R00DV

Blue Bird Body Company has determined that certain Blue Bird buses equipped with transit sliding pushout windows do not conform to Federal Motor Vehicle Safety Standard No. 217 pertaining to "Bus Window Retention and Release" requirements. On subject buses, the potential sticking and/or binding of the pushout window inner frame within the outer frame results in opening forces exceeding the requirements of FMVSS 217.

**RECALL R00DV
TRANSIT PUSHOUT WINDOW NONCOMPLIANCE
INSTRUCTIONS**

Figure 1

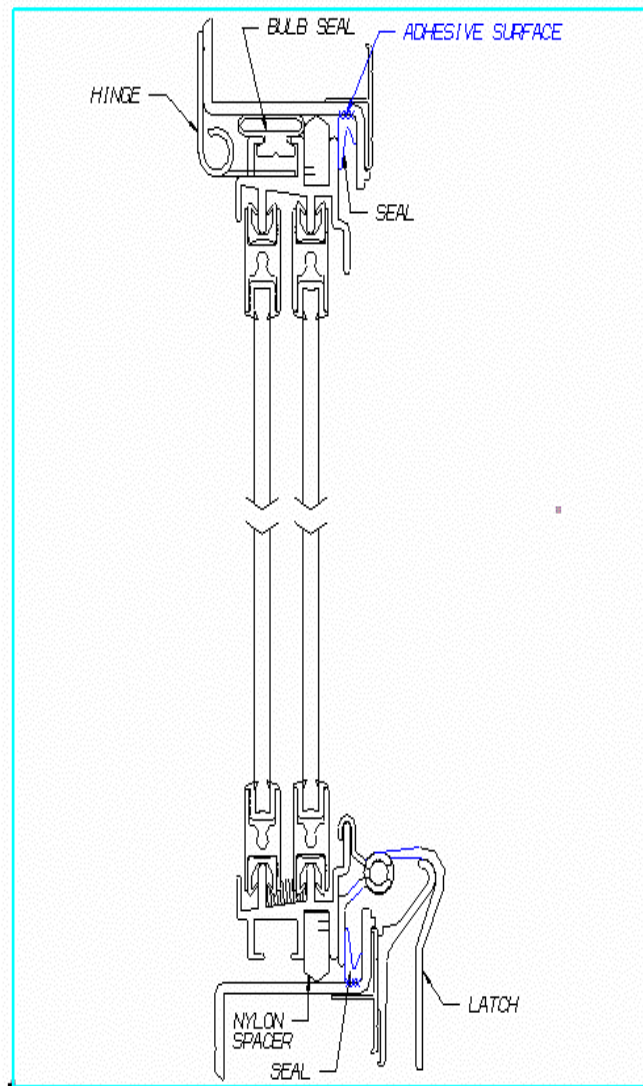
1. Release window and prop open with a secure device. Remove the existing weather strip seal and remaining glue. Glue should be removed using a naphtha-based solvent or mineral spirits. Do not scratch paint from window frame.
2. Install new weather strip seal, part number 0203323, as shown in Figure 1 on page 3. NOTE ORIENTATION OF SEAL. The 1/2 " edge should face out to seal against the pushout portion of the window. When installing seal start at the bottom center of window frame and work seal up and around window frame. **Do not pull seal tight across corners. Glue will release before setting.** Push seal into corners so that no tension is on seal throughout radius of corner. Route seal around window and overlap where seal starts for approximately 1/4". Cut seal smoothly and squeeze into gap where seal starts to ensure a water tight seal.

Figure 3

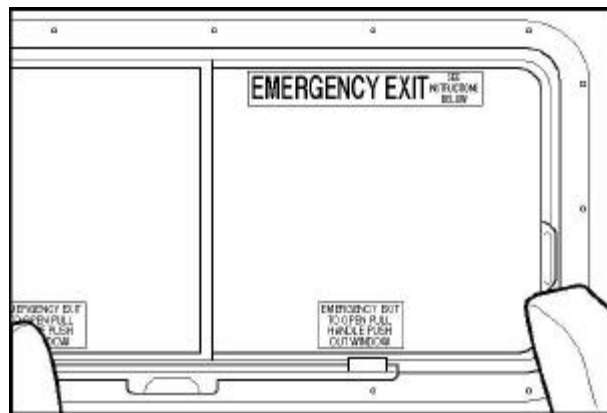
4. With the window held open, grind 1/8th of an inch off of the three (3) nylon spacers located on the bottom rail of the window. See Figure 3.

5. Close the window and be sure the nylon spacers do not interfere with the window sash when closing. If interference exists, then continue to grind off material from each spacer until clearance is achieved to permit required opening force..
